One cabinet, interchangeable filter modules

Reducer and retainer / proposed panel geometry

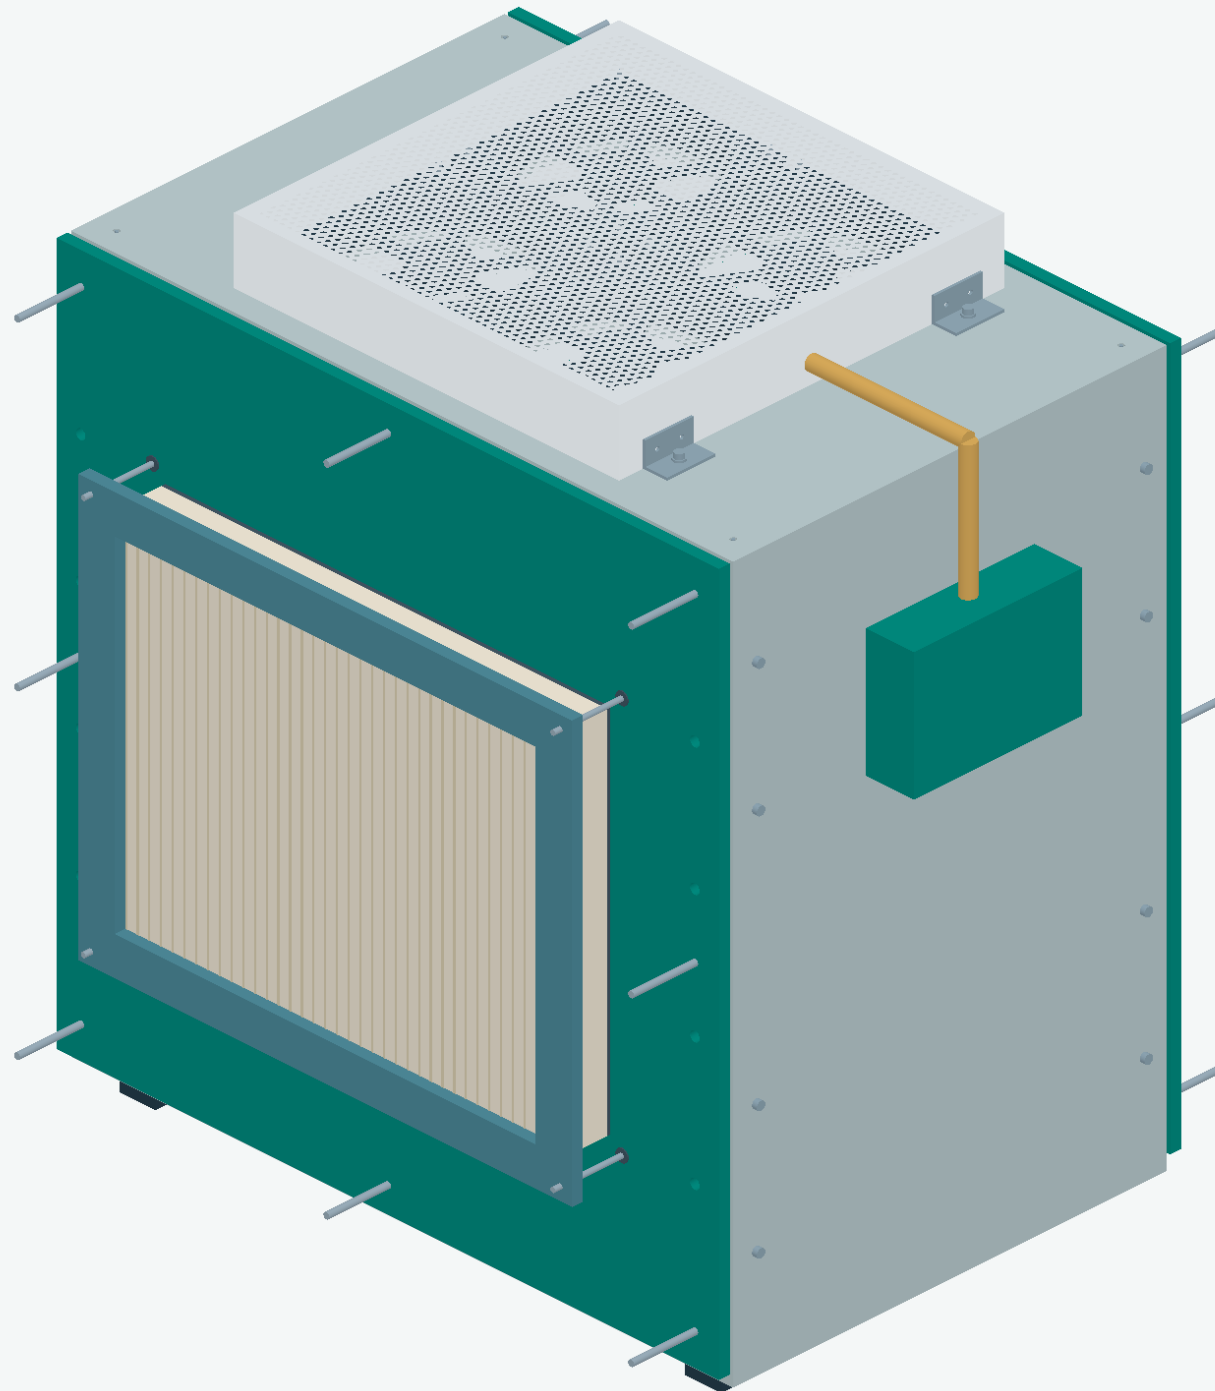
What changed

Two reducing plates adapt the same R01 cabinet to the published 370 x 290 x 40 mm STARKVIND envelope. Existing cabinet, fans, guards and outer seals are retained.

Sealing route

Cabinet -> original 495.3/475.3 mm gasket -> reducing plate -> assumed 370/350 by 290/270 mm gasket -> filter. Seal all new mounting feedthroughs; no unsealed screw holes into the plenum.

Positive support

Two proposed bent ledges per filter carry weight separately from clamping friction. Four M4 studs retain each removable frame. Final heads/nuts, bracket bends and strength remain unselected.

Do not transfer old airflow

Smaller openings and a different filter invalidate earlier flow estimates. Pressure curve, bypass, installed flow and particle removal remain unmeasured. OEM permits intended use only in STARKVIND appliances; this custom use is experimental.
